HISTORIC AND DESIGN REVIEW COMMISSION

HDRC CASE NO: 2019-173
ADDRESS: 504 KING WILLIAM
LEGAL DESCRIPTION: NCB 749 BLK 8 LOT 9,10, NW IRR 28.2FT OF 1 & NW 61.2 FT OF 2
ZONING: RM-4,HS
CITY COUNCIL DIST.: 1
DISTRICT: King William Historic District
LANDMARK: Steves, Albert - House
APPLICANT: Daniel Cruz/Design Coop SA
OWNER: Christopher Guerra
TYPE OF WORK: Construction of a second story front porch
APPLICATION RECEIVED: March 29, 2019
60-DAY REVIEW: May 28, 2019
CASE MANAGER: Stephanie Phillips

REQUEST:

The applicant is requesting a Certificate of Appropriateness for approval to construct a second level wrap around front porch. The porch railing will be constructed with metal posts.

Albert Steves Home ≈ 504 King William as originally designed and built. Photograph courtesy of Mary Carolyn George.

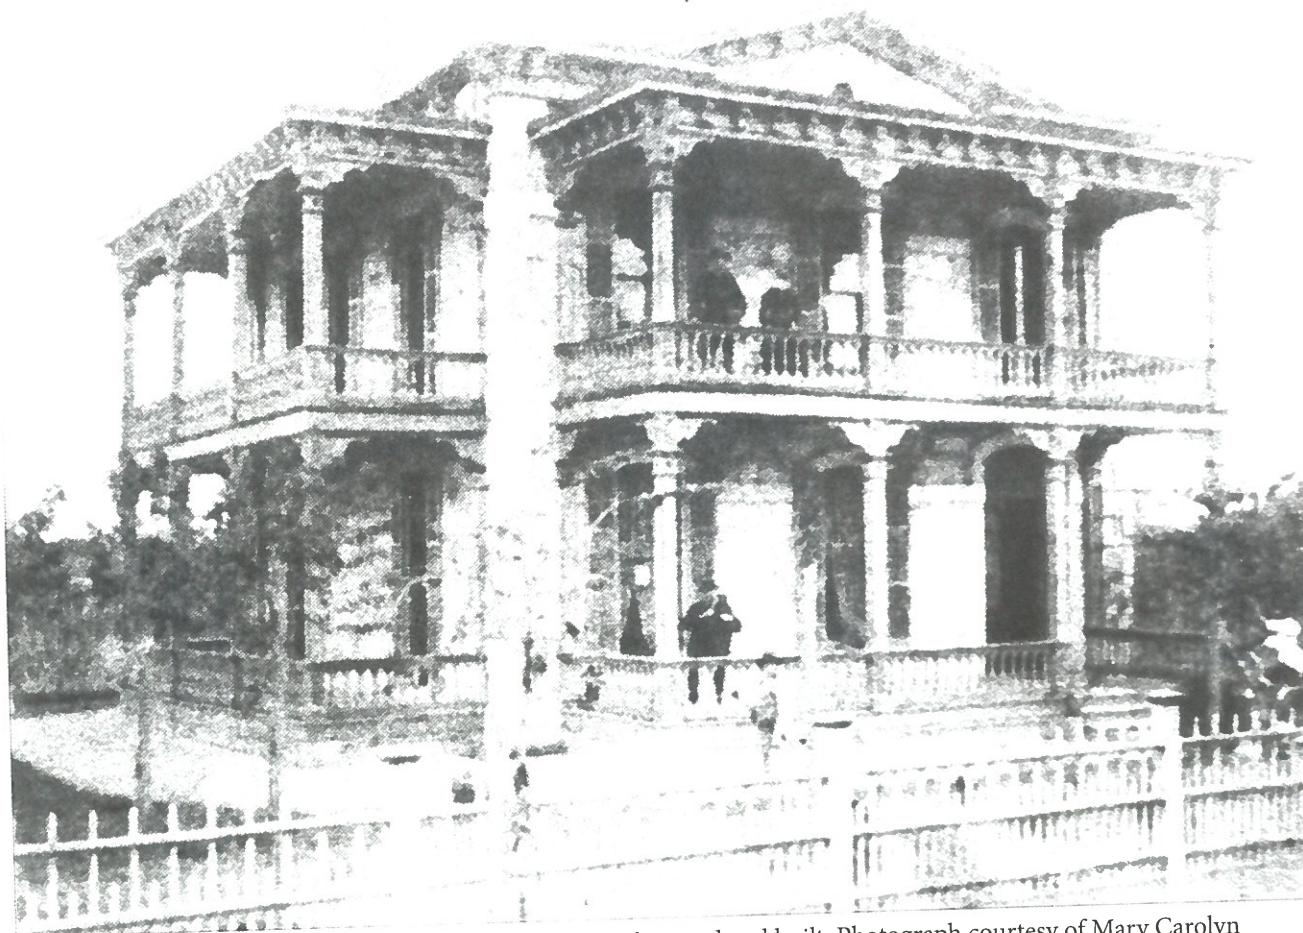
- c. LOCATION – The applicant has proposed to construct a second story wraparound porch. The porch will extend from the central front façade towards the rear of the structure, on the northern side elevation. The existing case stone decorative frieze above the front door will remain. Based on historic photographs of the structure, a wraparound porch existed previously in this location. Based on this evidence, staff finds the general location consistent with the Guidelines.

ELEVATION: GUARDRAIL
 SCALE: 1 1/2" = 1'-0"

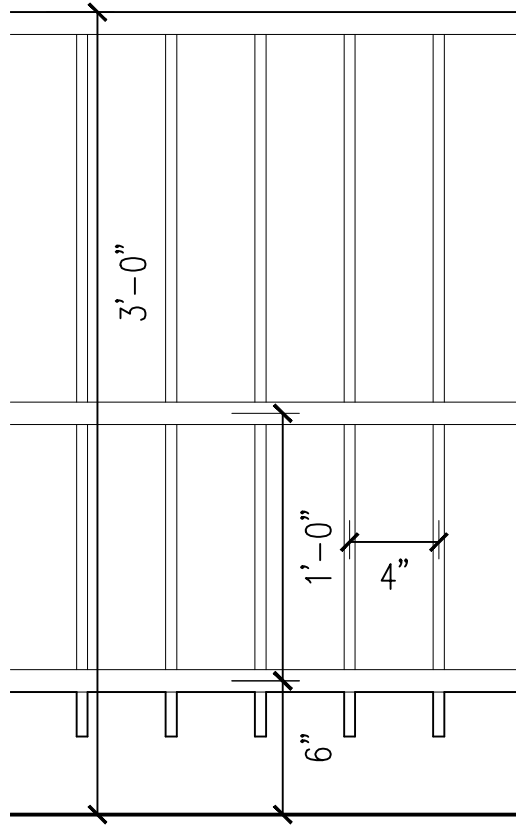
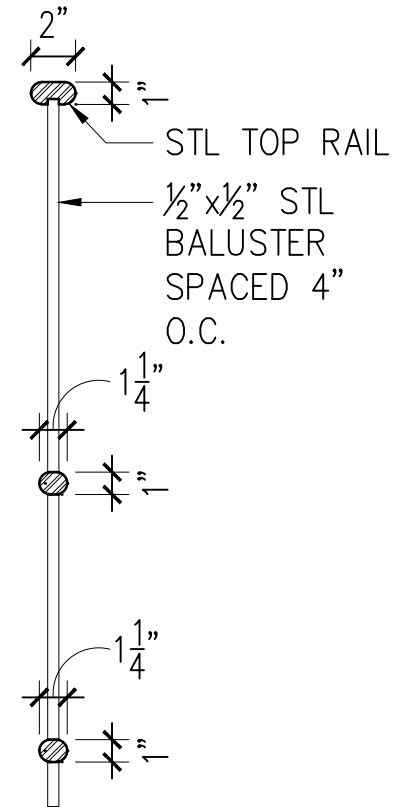
- d. DESIGN – The applicant has proposed a steel guardrail and composite decking for the porch floor. The supportive floor substrate is not indicated on the submitted plans. The guardrails will be 42” in height to comply with existing code requirements and will extend above the existing case stone frieze. The balustrades will be 1 ¼” in width with a 2” top rail. According to the Historic Design Guidelines, porches should be reconstructed based on accurate evidence of the original, such as photographs. If no such evidence exists, the design should be based on the architectural style of the building and historic patterns. Staff finds that the design as proposed is not consistent due to the photographic evidence of the previous porch. Staff finds that the applicant should restore the porch to its 1915 configuration, including the inclusion of wooden turned balustrades at their original height. The applicant may install a second guardrail structure, secondary in design and location, to achieve minimum code requirements.

Staff does not recommend approval of the porch modifications at this time. Staff recommends that the applicant propose a second story porch addition that restores the structure to its 1915 configuration as evidenced by archival photographs.
